Comment

# Comment on Liu et al. “Discrepancies of Measured SAR between Traditional and Fast Measuring Systems.” *Int. J. Environ. Res. Public Health*, 2020, 17, 2111

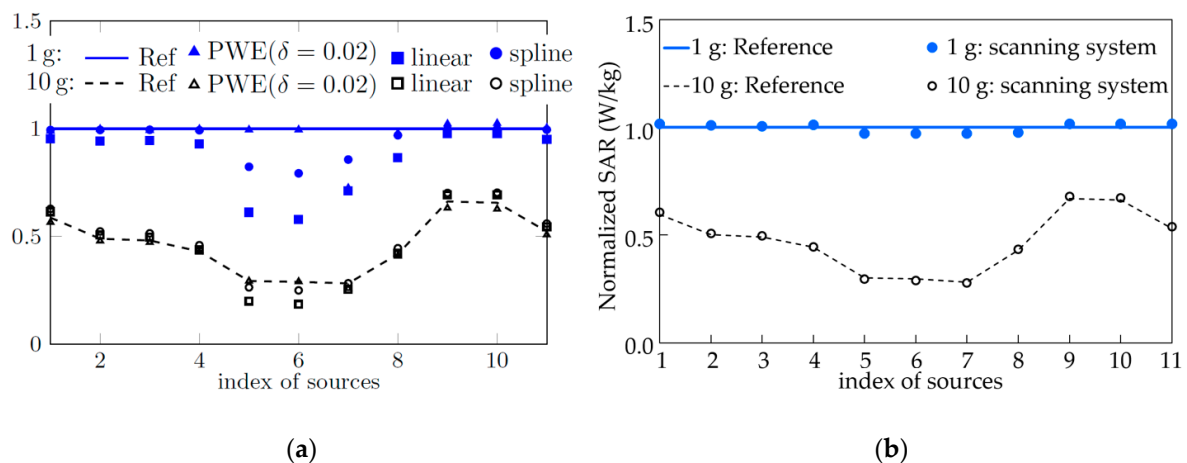
1. The scanning requirements of IEC 62209-1 [5] referred to in Liu et al. were already outdated, since the publication of IEC 62209-2 AMD1 in May 2019 [6], several months before the paper was submitted for publication. IEC 62209-2 AMD1 has stricter scanning requirements for sources with strong field decay. The authors also applied linear interpolation and extrapolation to some of their data despite the standard clearly recommending more accurate interpolation and extrapolation methods, such as splines and polynomials. Applying splines reduces the maximum errors to 20% compared to 40% using linear methods.

2. The high measurement errors for sources 5 and 6 (i.e., monopoles at frequencies from 5–6 GHz) in the paper by Liu et al. are due to an additional mistake in the application of the scanning parameters. The authors applied the same parameters as used at lower frequencies instead of the parameters at 5500 MHz and 5800 MHz for sources 5 and 6, respectively. Using the frequency-dependent scanning requirements would have reduced the errors from 20% to less than 4% for these two sources.

Figure 1b shows the results of the analysis using the same raw data with state-of-the-art scanning and evaluation parameters. The actual measurement errors are less than 3% for all 11 source antennas for any lateral shift in the measurement grids with respect to the antenna. Results were generated using the post-processor engine of cDASY6 V6.4 and later using its standard EX3DV6 probes (SPEAG, Switzerland, [www.speag.swiss](http://www.speag.swiss)). The results published by Liu et al. [1] are shown in Figure 1a. Table 1 compares the zoom scan parameters stated by Liu et al. [1,4] and those used by cDASY6 V6.4 applying IEC 62209-2 AMD1 for antenna 7.
